Subject: BAR Actions - March 20, 2018 - 321 East Main Street

BAR 18-03-03
321 East Main Street
Tax Parcel 330226000
321-323 East Main Street LLC, Owner/ Alan Goffinsk, Applicant
Proposed public mural

CITY OF CHARLOTTESVILLE BOARD OF ARCHITECTURAL REVIEW STAFF REPORT March 20, 2018

View of 321 East Main Street from the north, looking south down 4th Street.

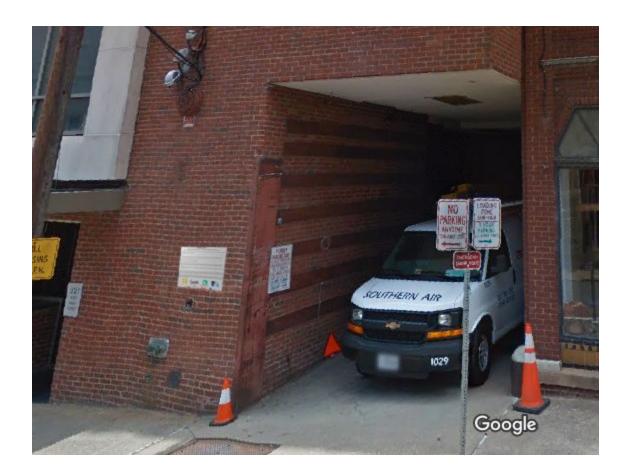
The BAR should discuss how the mural will be put on the building, as well as if a mural is appropriate in this location.

- The building is a non-contributing structure in the ADC
- The proposed location is on the building's non-primary elevation and will not be visible from the bricked pedestrian mall.
- The mural will not interfere with or *cover* any architectural elements of the wall.
- The mural is in response to a significant event in the city's history and is intended to offer to the community a unique opportunity, through art, to heal and move forward from that event.
- The mural represents the work of a prominent, nationally-recognized artist working in collaboration with local artists.

Schwarz moved: Having considered the standards set forth within the City Code, including City Design Guidelines for Rehabilitation, and Public Design and Improvements, I move to find that the proposed mural satisfies the BAR's criteria and guidelines and is compatible with this property and other properties in the Downtown ADC district, and that the BAR approves the application with the following modifications the mural needs to be sized per Mohr's description and discussion during the BAR meeting. The mural should follow the line of the large window casing height across and come off the corner probably in line with that first window (based on the two sketches provided by Jeff Werner). Also, the final design and imagery needs to come back to the BAR for final approval, and that the artist recognizes that the mural's content will be visible from the street and that it should be to that scale. As presented the color and composition is acceptable. This mural is acceptable because it is on a non-contributing structure in the ADC District, is not located on a primary façade, and it will not be seen from the pedestrian mall. Mohr seconded. Approved (8-0).
